**LEReC cooling section meeting (10/29/14) minutes:**

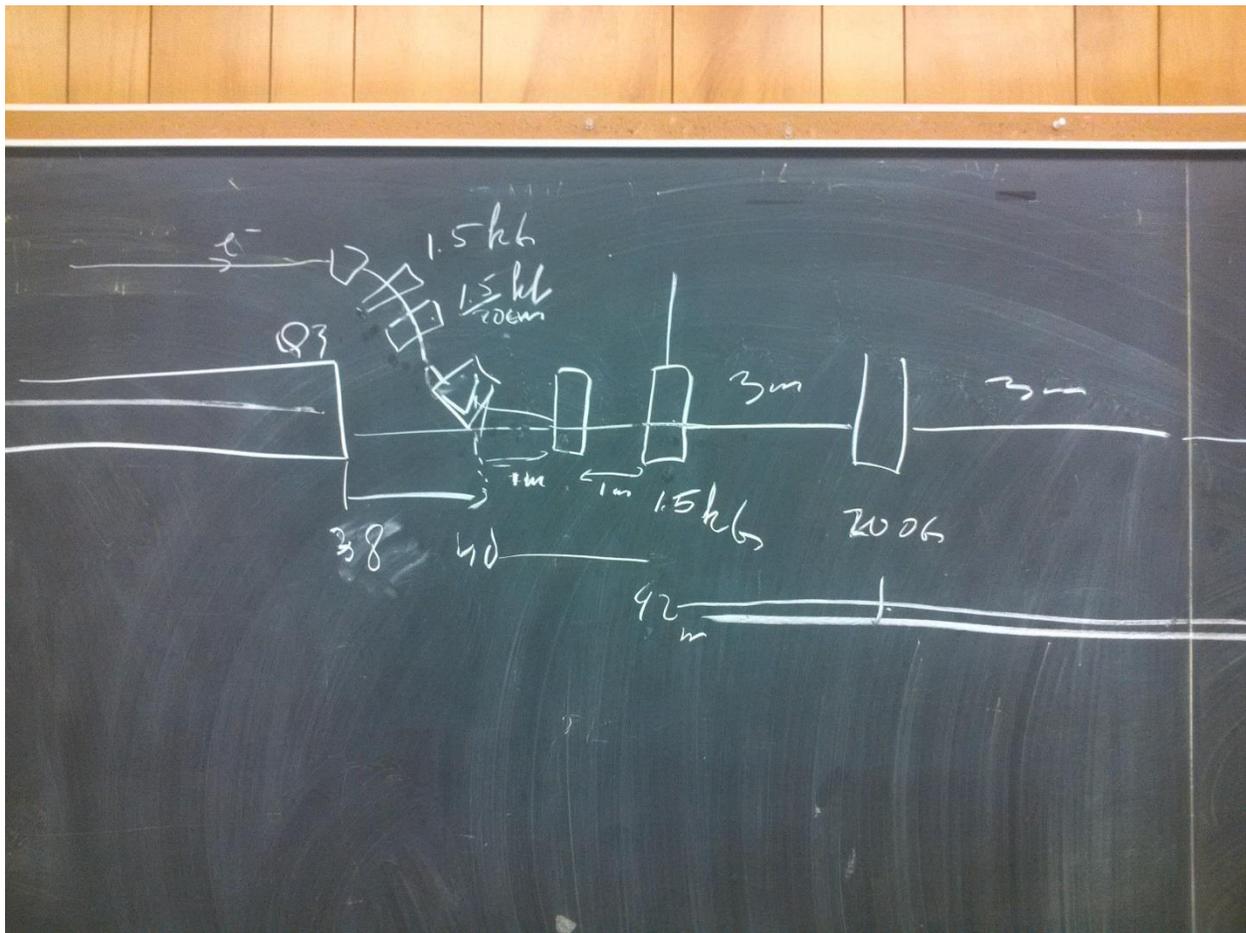
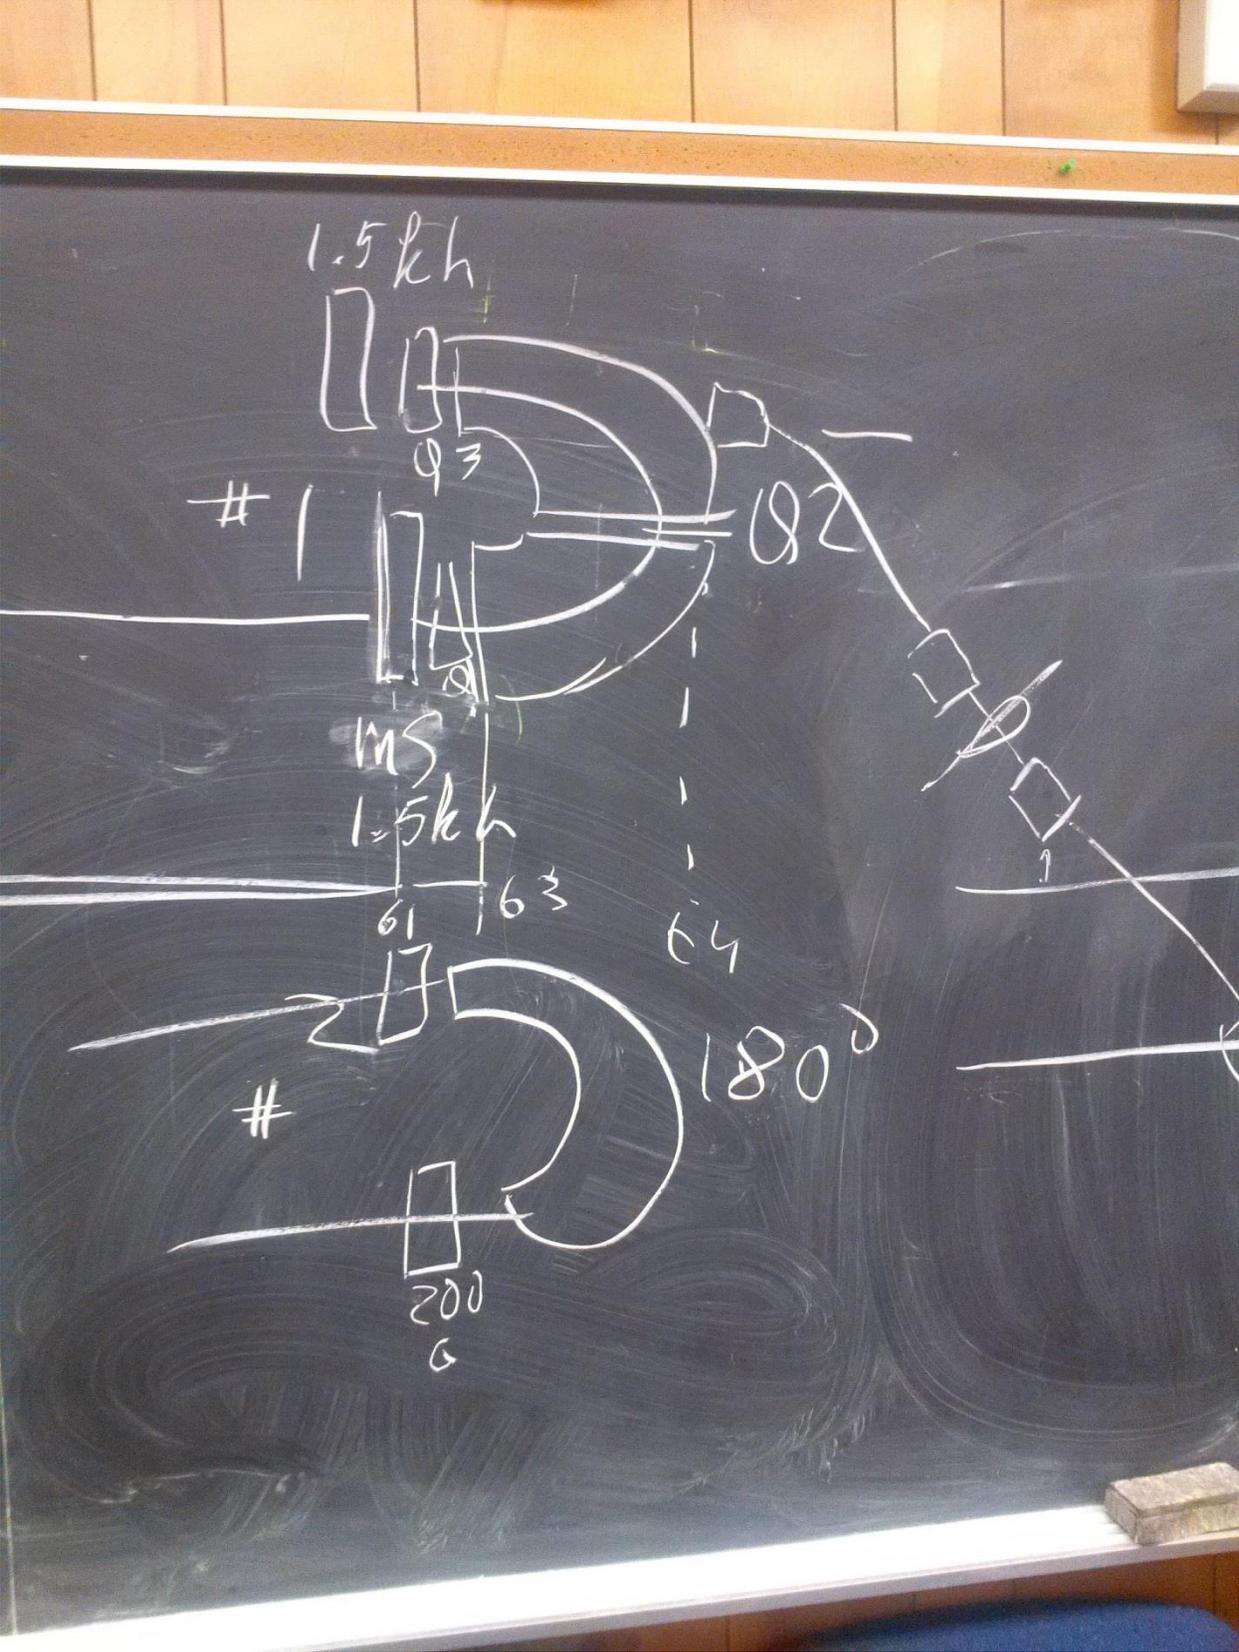
J. Kewisch gave some options on the beam line component layout:

When W. Meng returns we will request a 180o dipole design. The exact distance between blue and yellow lines is at 64 meters from the IP and the beam line angle is needed (Action: G. Whitbeck). There is margin in the accuracy of the positioning.

Compensating dipoles will be included in the design to simplify the beam line location requirements.

Karim had models of the low field solenoid and the 45o dipole. The next step is to get them into the 01:00 RHIC beamline model per the blackboard photo's (Action: G. Whitbeck).
